**Brookleigh Eastern Primary
School, Brookleigh, Burgess
Hill**

**Transport Statement
Addendum**

ROAD SAFETY AUDIT STAGE 1

PROPOSED CHANGES TO EASTERN BRIDGE LINK ROAD IN ASSOCIATION WITH THE PROPOSED 2FE PRIMARY SCHOOL DEVELOPMENT

Figure 5.1: Indicative Remedial Measures

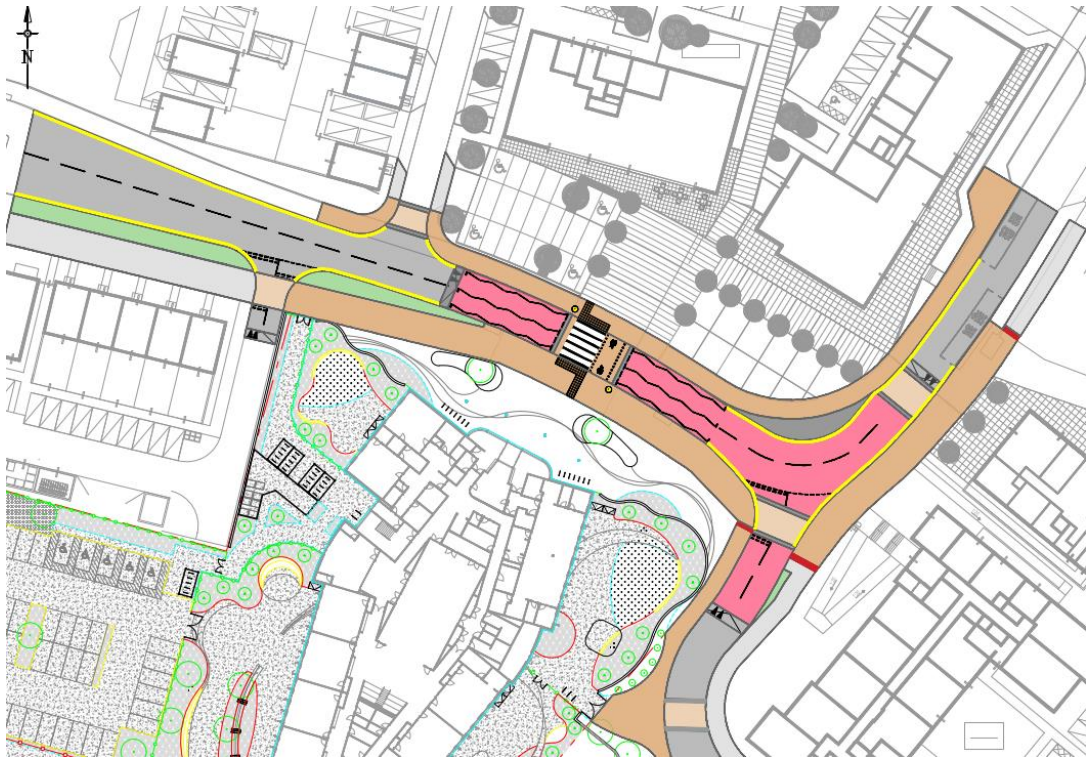
- 5.2.1 In the event that there are issues emerging adjacent to the Primary School in relation to set-down and parking, it is proposed to implement further road markings along the immediate EBLR frontage which will provide enforceable restrictions preventing parking/ set down on the EBLR.
- 5.2.2 An indication of these measures is included in Figure 5.1 below. It should be noted that these are very much indicative at this stage and consultation in terms of any final scheme will need to be had with MSDC (as planning authority), WSCC (as highway authority), the school and Sussex Police.

14176 CRH XX XX DR H 6180 P2 Landscaping Layout External Areas
D3347-FAB-00-XX-DR-L-1100-PL01

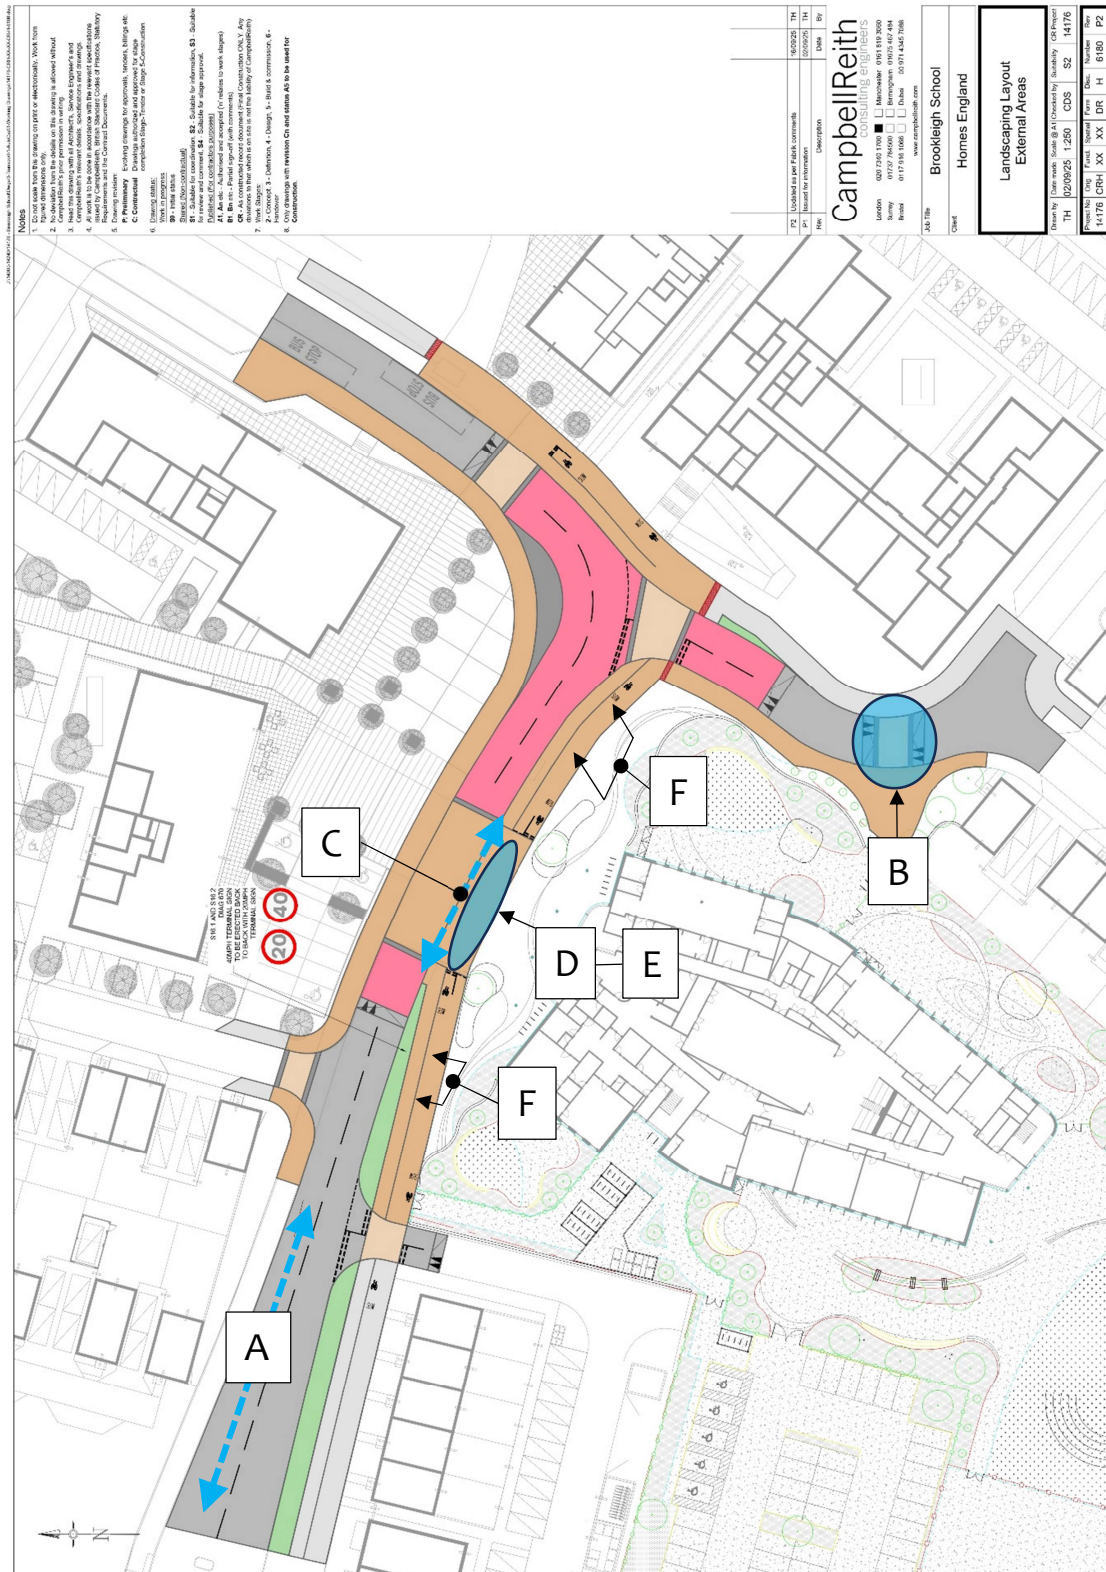
The drawings and AI generation illustration details that the entry to the Brookleigh School will be open plan with the carriageway and footway at the same level. It is noted that the AI generated illustration indicates that bollards are to be proposed between the back of the footway and the area immediately outside the school doors.

The drawings and AI generation illustration details that the entry to the Brookleigh School will be open plan with a segregated cycleway entering the footway outside the school entrance.

The drawings and AI generation illustration details that the entry to the Brookleigh School will be open plan with a segregated cycleway entering the footway outside the school entrance.

The drawings and AI generation illustration details that the entry to the Brookleigh School will be open plan with the carriageway raised to the same level as the footway/cycleway.

The drawings provided do not indicate any signage at this stage. The Audit Team therefore cannot ascertain whether there will be any road safety concerns. In such a scheme where there are multiple users: information; informative, directional and tactile, is paramount to provide all road users sufficient knowledge of the environment.

RSA Problem Number	RSA Problem	RSA Recommendation	Design Organisation Response	Design Organisation Response	Agreed RSA Action
3.1.1	Insufficient drainage may result in water ponding and potential slip hazard for powered two wheelers resulting in loss of control and potential personal injury or damage only type incidents. No details have been provided in respect of surface water drainage, and it is therefore not possible to ascertain whether there will be any safety implications. Poor drainage may result in the collection of surface water which could increase the risk of a slip hazard for non-motorised users or resulting in vehicle loss of control leading to potential personal injury or damage only incidents, particularly in inclement weather conditions.	It is recommended that adequate surface water drainage is provided within the vicinity of the scheme.	NOT ACCEPTED The EBLR (Holmbush Avenue) itself has been subject to detail design and been through a separate road safety audit. It is therefore respectfully suggested that all matters regarding adequate surface water drainage for the EBLR have been considered prior. Any changes to the surfacing will be subject to further information at any detail design stage.

3.1.2	Insufficient carriageway space at junctions, accesses or on bends may cause sudden braking and unexpected obstruction resulting in potential rear end shunts or side swipe type collisions. The Audit Team have not been provided with any Auto Tracking drawings. Consequently, there is concern that insufficient carriageway space may increase the risk of collision between vehicles travelling simultaneously.	It is recommended that Auto Tracking Drawings are provided showing all manoeuvres throughout the scheme.	NOT ACCEPTED The EBLR (Holmbush Avenue) itself has been subject to detail design and been through a separate road safety audit. It is therefore respectfully suggested that all matters regarding swept path analysis and appropriate carriageway spacings for the EBLR (and associated junction to the east of the school) have been considered prior.

RSA Problem Number	RSA Problem	RSA Recommendation	Design Organisation Response	Design Organisation Response	Agreed RSA Action
3.1.3	Parking may affect the free flow of traffic through Eastern Bridge Link Road which could increase the risk sudden braking, avoidance manoeuvres, pedestrian or cycle strike, cycle loss of control or damage only incidents. The drawings/information provided does not indicate that any parking restrictions are to be proposed within the extents of the scheme. At peak times and once the school is fully subscribed there will be hundreds of people walking, cycling and driving to access the school. This will result in high peak volumes. As with all schools parking can be an issue as parents with limited time tend to drive their children to school regardless of the distance from home.	It is recommended that parking restrictions are introduced from the beginning.	PARTIALLY ACCEPTED The previously agreed Brookleigh 'Street Design and Adoption Manual' states in Section 4.5 and 4.6 that there will be no signs or lines within Brookleigh and that this section (5a) will rely on positive design, and physical environment to calm traffic. However, following discussion with West Sussex County Council (as Highway Authority), it is become apparent that a formal crossing is to be introduced as part of any school scheme. This crossing facility will include zigzags on both approaches which prevent any parking from occurring. Following installation of this crossing (prior to the school opening), the parking behaviour will be monitored and managed. Should there be a need for further parking restrictions these could be installed as part of the Stage 4 Road Safety Audit process.

RSA Problem Number	RSA Problem	RSA Recommendation	Design Organisation Response	Design Organisation Response	Agreed RSA Action
3.3.1	Raised table on the bend may increase the risk of loss of control incidents at this location. Vehicles negotiating the bend are already subject to lateral acceleration, and the introduction of a vertical deflection at this location creates conflicting vehicle dynamics. As a result, drivers may experience sudden changes in tyre loading and reduced grip while steering, increasing the likelihood of loss of control.	It is recommended that the raised table be relocated to a section of straight alignment where approach visibility is adequate and where vertical deflection will not conflict with lateral vehicle loading. If relocation is not feasible, the designer should consider alternative traffic-calming measures that do not introduce vertical displacement on a bend, and/or provide enhanced advance warning and conspicuity measures to mitigate the risk.	ACCEPTED It is proposed that the vertical deflection element of this raised table be removed. We feel it is appropriate for a uncontrolled crossing to remain in this position given the presence of the nursery / reception entrance. Vehicle speeds are expected to be very low in this area.

RSA Problem Number	RSA Problem	RSA Recommendation	Design Organisation Response	Design Organisation Response	Agreed RSA Action
3.4.3	Cyclists may be at risk of strike from approaching vehicles. The Audit Team are concerned that this arrangement may result in conflict between cyclists and vehicles within the carriageway. As noted above children tend to move unpredictably, often walk together with parents in groups and can be easily distracted. This may result in cyclists having to take avoidance actions which could result in them entering the carriageway at risk of being struck by an approaching vehicle.	It is recommended that the segregated cycle link is redirected across the Eastern Bridge Link Road prior to the school entrance area.	NOT ACCEPTED For the reasons stated in 3.4.2 above. It is also considered that there would be school personnel adjacent to the school entrance during pick up and drop off times to help manage the potential conflict.

3.5.1	Insufficient signage and tactile information may result in conflict between users. The drawings provided do not indicate any signage at this stage. The Audit Team therefore cannot ascertain whether there will be any road safety concerns. In such a scheme where there are multiple users: information; informative, directional and tactile, is paramount to provide all road users sufficient knowledge of the environment.	It is recommended that clear and concise tactile and signed information is provided to all users.	ACCEPTED As discussed above, the SDAM and wider masterplan discourages the uses of signage and lining. The tactile arrangement will be reviewed to ensure it provides clear direction for its users as part of the amended scheme to introduce a formal crossing facility.

14176 CRH XX XX DR H 6180 P4 Landscaping Layout External Areas
D3347-FAB-00-XX-DR-L-1100-PL01

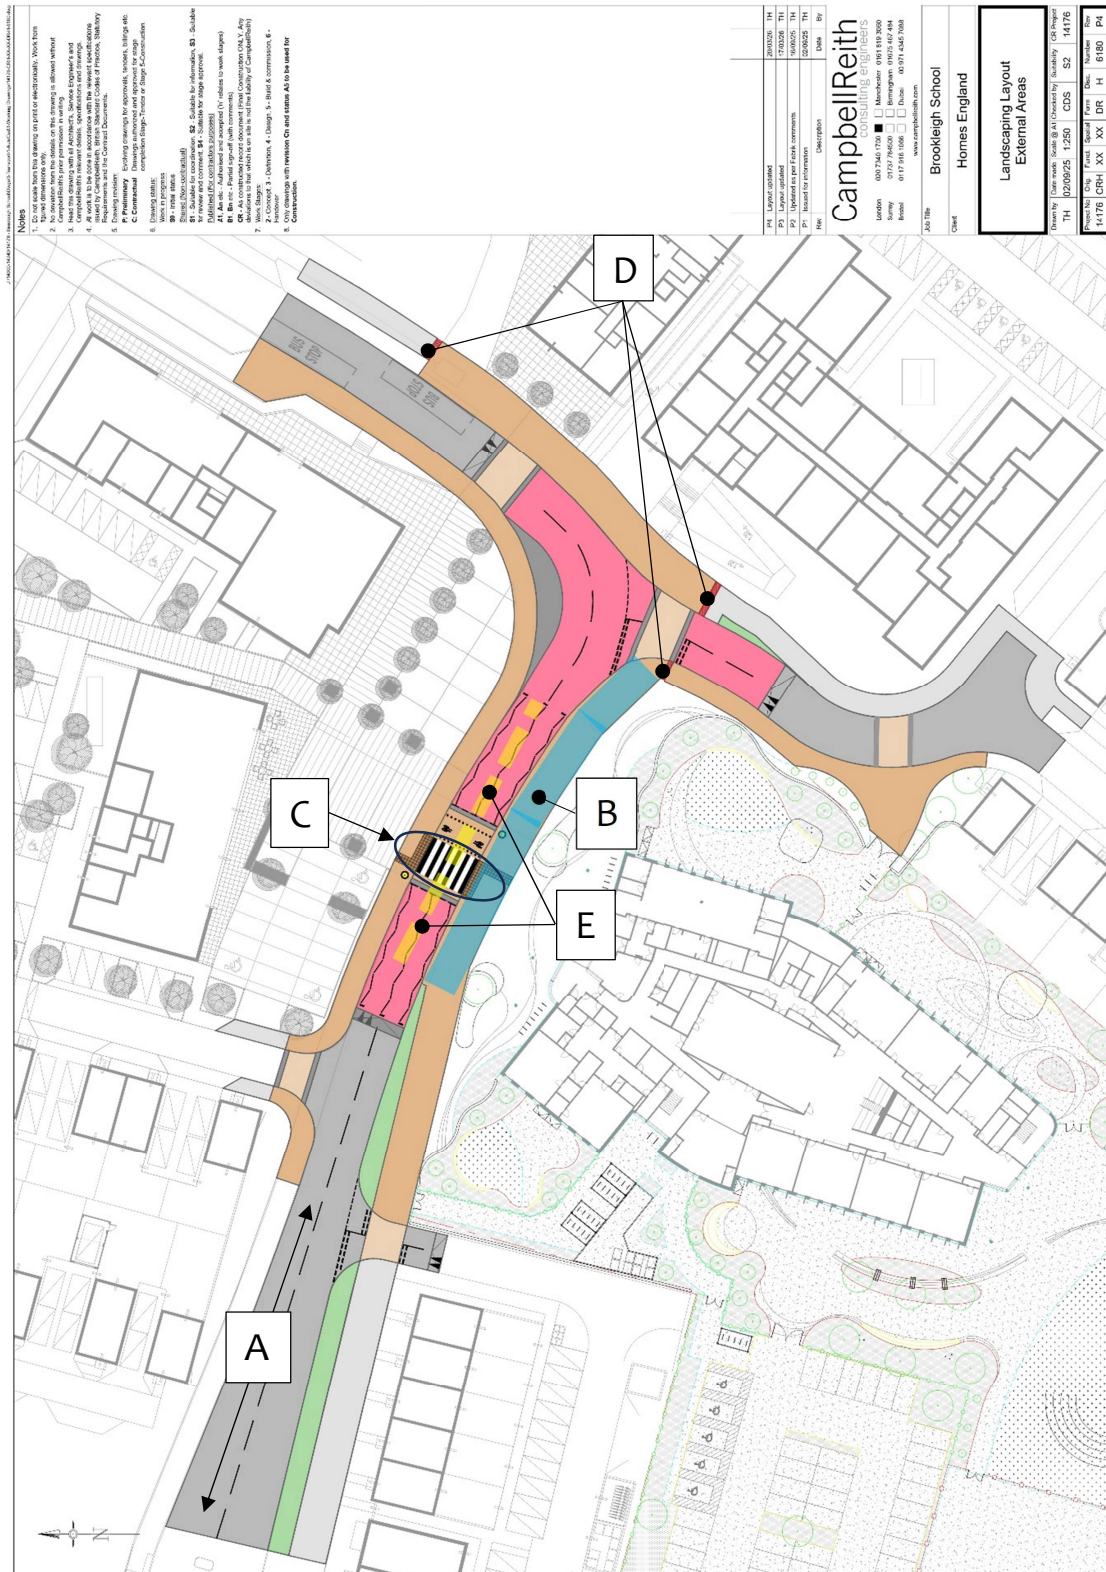
The drawings and AI generation illustration details that the entry to the Brookleigh School will be open plan with the carriageway and footway at the same level. The Audit Team are concerned that this arrangement may increase the risk of a vehicle entering or parking on the footway/cycleway at risk of striking pedestrians/cyclists.

RECOMMENDATION: It is recommended that additional measures are introduced to provide detectable features within the crossing for the blind or visually impaired pedestrian.

The drawings indicate that a raised table is proposed along the length of the school frontage. Within the raised carriageway a parallel crossing has been introduced to provide a designated crossing area. The Audit Team are concerned that the area either side of the crossing is open and flush with the footway, which may encourage pedestrians and cyclists to cross anywhere within the vicinity of the crossing expecting that drivers will give way. This may result in an increased risk of pedestrian/cyclist strike at this location.

The drawings provided do not indicate any signage at this stage. The Audit Team therefore cannot ascertain whether there will be any road safety concerns. In such a scheme where there are multiple users: information; informative, directional and tactile, is paramount to provide all road users sufficient knowledge of the environment.

RSA Problem Number	RSA Problem	RSA Recommendation	Design Organisation Response	Design Organisation Response	Agreed RSA Action
3.4.2 (March 26)	Visually Impaired or blind pedestrians may be vulnerable to strike at the parallel crossing. The proposed parallel crossing is located on a raised table and is therefore flush with the adjacent footways. While the facility provides priority for both pedestrians and cyclists, the arrangement offers no detectable tactile or audible indication to blind or partially sighted users that they are entering a controlled crossing environment. A visually impaired pedestrian will correctly locate the crossing point using the blister tactile paving and L-stem. However, upon reaching the crossing, the absence of a detectable kerb upstand means they cannot identify the edge of the carriageway or distinguish between pedestrian space, the cycle crossing, and the vehicle running lane. The zebra markings and cycle markings are visual cues only and may not be perceived by blind pedestrians. The parallel cycle crossing introduces an additional stream of quiet, fast-moving vehicles (cycles and e-bikes) that may not be audible. As a result, a visually impaired pedestrian may inadvertently step into the cycle crossing or carriageway without realising they have left the footway, placing them at risk of strike and personal injury.	It is recommended that additional measures are introduced to provide detectable features within the crossing for the blind or visually impaired pedestrian.	PARTIALLY ACCEPTED It is proposed that a slight upstand will be proposed between the shared footway / cycleway and the crossing itself. Tactile cones will also be installed as part of the detailed design to assist the visually impaired. There is also an opportunity to include audible signals but will be guided by the Highway Authority, given this is in a wider residential settlement.

RSA Problem Number	RSA Problem	RSA Recommendation	Design Organisation Response	Design Organisation Response	Agreed RSA Action
3.4.3 (March 26)	Cyclists not provided with suitable onward connectivity which may increase the risk of conflict with other road users. There are several areas where the drawings indicate that a transition area between facilities where corduroy paving has been used to indicate the end of a cycle/shared footway/cycleway. However, no signage is detailed within the drawings presented for audit. It is therefore not possible to ascertain the proposal at these locations or any potential safety concerns related to this.	It is recommended that at all areas of transition between facilities, or at the end of a facility users are provided with clear, concise information regarding the expected onward connectivity.	ACCEPTED The presence of a continuous cycle route throughout the EBLR (Holmbush Avenue) and the wider Brookleigh development is one of its key sustainable travel features. There is potential to include sensitive signage (potentially bollards) to highlight the end of any formal cycle route, and this could be captured as part of the detail design process.

3.4.4 (March 26)	Pedestrians and Cyclists may choose to cross the road at areas away from the parallel crossing resulting in increased risk of strike from approaching vehicles. The drawings indicate that a raised table is proposed along the length of the school frontage. Within the raised carriageway a parallel crossing has been introduced to provide a designated crossing area. The Audit Team are concerned that the area either side of the crossing is open and flush with the footway, which may encourage pedestrians and cyclists to cross anywhere within the vicinity of the crossing expecting that drivers will give way. This may result in an increased risk of pedestrian/cyclist strike at this location.	It is recommended that measures are introduced to encourage use of the designated crossing point.	PARTIALLY ACCEPTED The proposed location of the parallel crossing is on a desire line for parents and pupils travelling from the north. While the observation is noted, it is not intended to introduce measures such as railings to funnel parents and pupils to the proposed crossing facility. The use of the wider raised table could be included in the initial monitoring and management of the area, once the school opens.

RSA Problem Number	RSA Problem	RSA Recommendation	Design Organisation Response	Design Organisation Response	Agreed RSA Action
3.5.1	Insufficient signage and tactile information may result in conflict between users. The drawings provided do not indicate any signage at this stage. The Audit Team therefore cannot ascertain whether there will be any road safety concerns. In such a scheme where there are multiple users: information; informative, directional and tactile, is paramount to provide all road users sufficient knowledge of the environment.	It is recommended that clear and concise tactile and signed information is provided to all users.	ACCEPTED As discussed above, the SDAM and wider masterplan discourages the uses of signage and lining. The tactile arrangement will be reviewed to ensure it provides clear direction for its users as part of the amended scheme to introduce a formal crossing facility.
